Road Section Deviation Request, letter from YarrowBay
January 27, 2014

Deviation from road section - alternative rain garden width/ configuration

RE: The Villages MPD Preliminary Plat Phase 1A Road Section Deviation

EXHIBIT 1

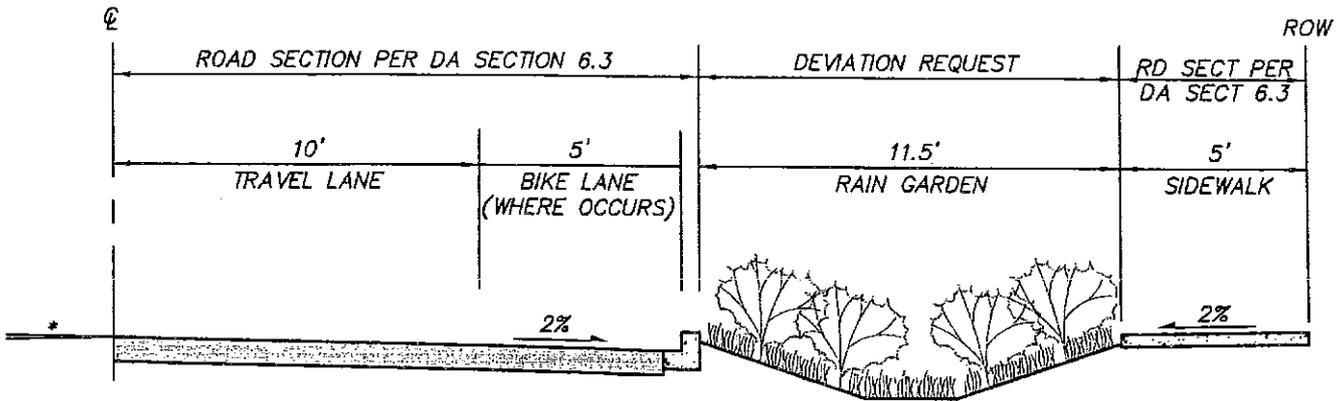
A deviation request has previously been submitted and approved (PUB12-0024) to allow the use of rain gardens in the street Right-of-Way for stormwater management with a width of 11.5 feet located between the curb and the sidewalk. Exhibit 1 attached shows the rain garden configuration and location previously approved. This deviation is a request from the prior approved deviation to allow the use of alternative rain garden widths/configurations and to allow the rain gardens to be located outside of the street Right-of-Way in the adjacent Open Space Tracts. The variable width rain gardens for this deviation request would be located in the adjacent Open Space Tract either between the curb and sidewalk/walkway or between the sidewalk/walkway and the back of the Open Space Tract as shown on the attached exhibits 2 and 3. The rain gardens are proposed to be used within Preliminary Plat 1A (PLN 11-0001) to integrate Low Impact Development ("LID") techniques into the implementing project as required by Section 7.7.7(A)(6) of the Villages MPD Development Agreement dated December 12, 2011 and the Villages MPD Condition of Approval No. 67.

**RAIN GARDEN LOCATION AND SIZE APPROVED WITH
PUB12-0024**

EXHIBIT 2

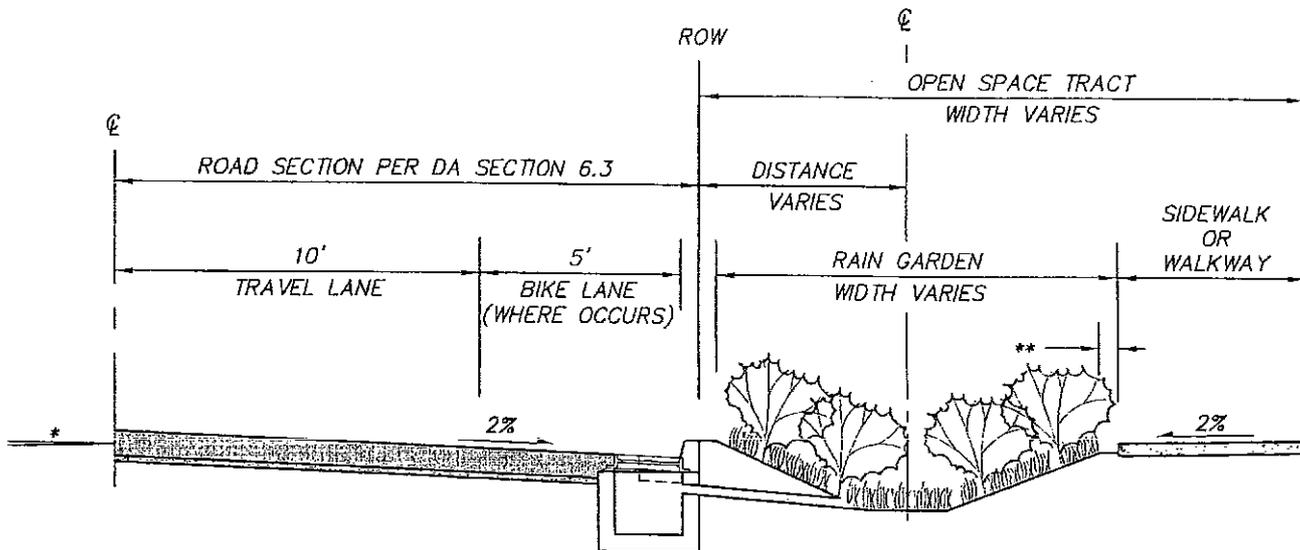
PROPOSED RAIN GARDEN LOCATED BETWEEN R-O-W AND SIDEWALK.

** NOTE: PROVIDE MINIMUM OF 6 INCH WIDE LEVEL AREA ADJACENT TO SIDEWALK BEFORE SLOPING DOWN INTO RAIN GARDEN.

EXHIBIT 3

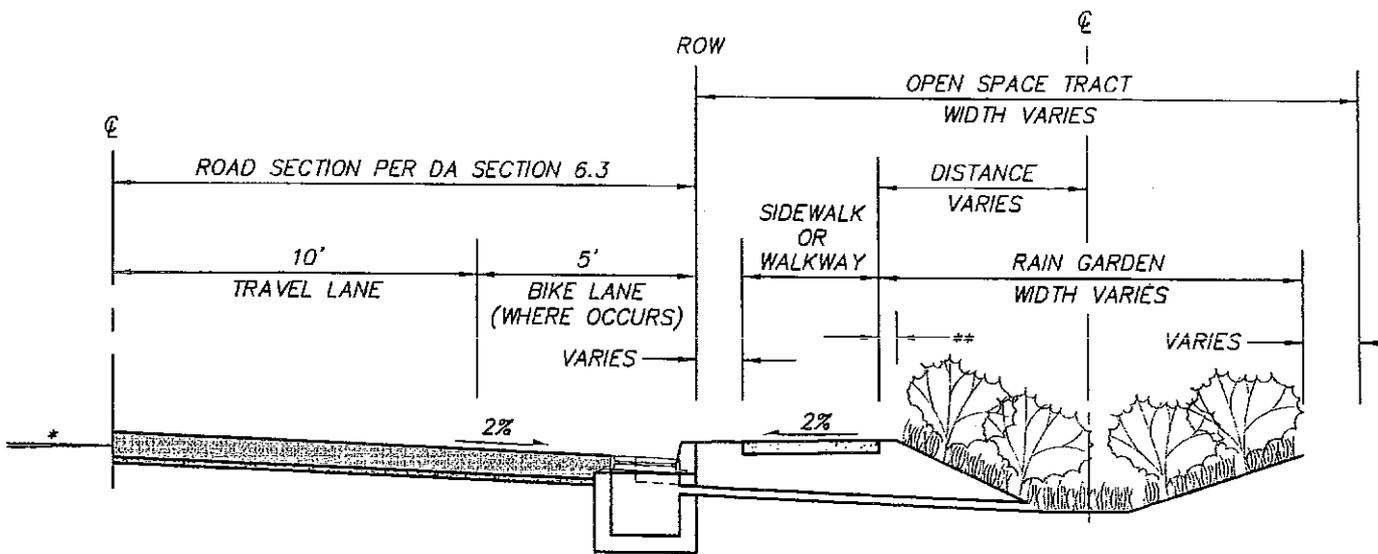
PROPOSED RAIN GARDEN LOCATED BETWEEN SIDEWALK AND TRACT LINE.

** NOTE: PROVIDE MINIMUM OF 6 INCH WIDE LEVEL AREA ADJACENT TO SIDEWALK BEFORE SLOPING DOWN INTO RAIN GARDEN.
